FROM: Wisconsin Public Service Green Bay Wis 54305 E W James			DATE OF DOC 12-2-74	DATE REC'D 12-5-74	LTR XX	TWX	RPT	OTHER
TO: Mr Purple			ORIG one signed	CC	OTHER	SENT AEC PDR <u>XX</u> SENT LOCAL PDR <u>XX</u>		
CLASS	UNCLASS XXXXXX	PROP INFO	INPUT	NO CYS REC'D 1		DOCKET NO: 50-305

PLANT NAME: Kewaunee

Subject: Docket 50-305
Operating License DPR-43
ECCS Evaluation Model Parameters

FIGURE 1

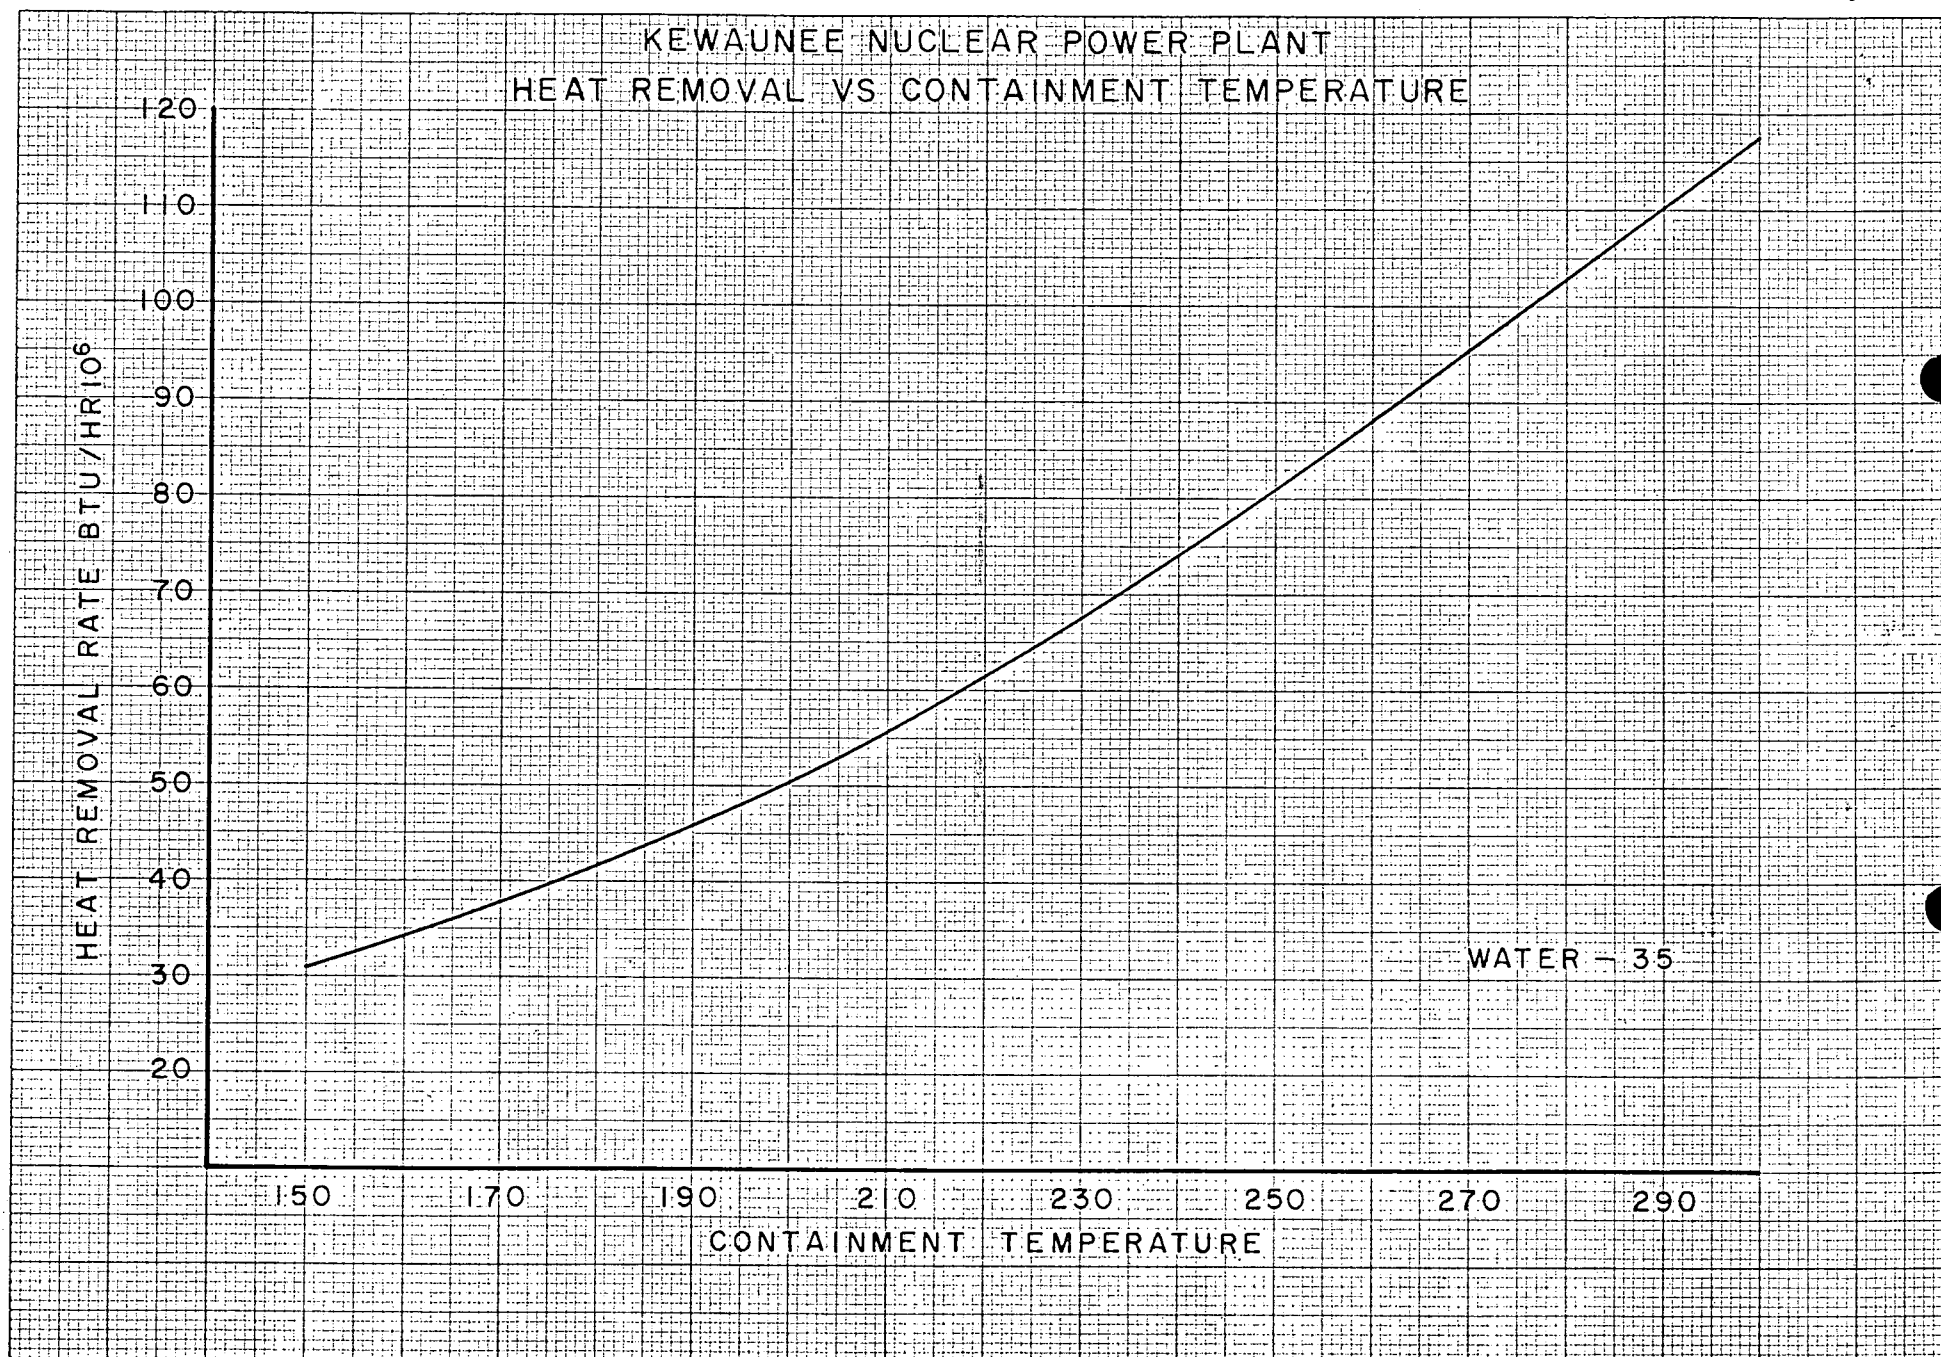
- a) Fan-cooler heat removal rate as a function of containment atmosphere temperature. Show that minimum operational values of service water temperature have been used in determining the fan-cooler heat removal rate.
- b) Mass and energy release rates to the containment as a function of time during the blowdown, refill, and reflooding periods of the accident. Include any spilled ECCS water.

- a) Figure 1, attached provides the fan cooler heat removal rate as a function of containment atmosphere temperature. The variation between the 35°F cooling water temperature and analysis value of 32°F temperature is negligible.
- b) Table 2, attached, provides the blowdown mass and energy releases as a function of time for the most severe break. Table 3, attached, provides the reflood mass and energy releases as a function of time. Table 4, attached, provides the broken loop accumulator flow to the containment as a function time.
